315' PRESTRESSED DOUBLE TEE GIRDER BRIDGE
ECKERT ROAD BICYCLE PATH OVER BOISE RIVER
STA. 119+60

SHOP DRAWING REVIEW

Drawing No 6404-A SD Sht 1 of 19

IDAHO TRANSPORTATION DEPARTMENT
F.A.P. NO. 51P-7643(101)
KEY NO. 5752
ADA COUNTY

35~POSTS~62316W

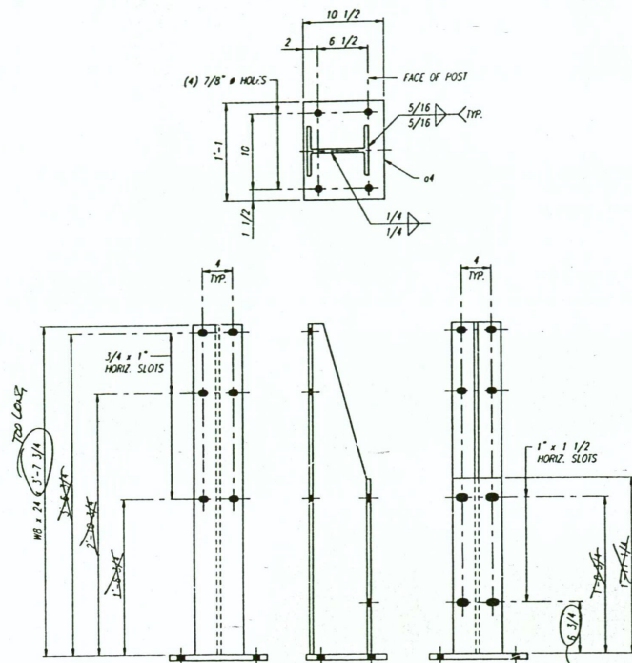
TOO MUCH
NEED TO ADJUST WITH RESPECT
TO EXISTING CURB THAT IS
BEING USED INSTEAD OF A
NEW CURB (WHICH WAS SHOWN
IN THE PLANS). MAINTAIN
1/4" FROM WORKING SURFACE
TO BOTTOM RAIL.
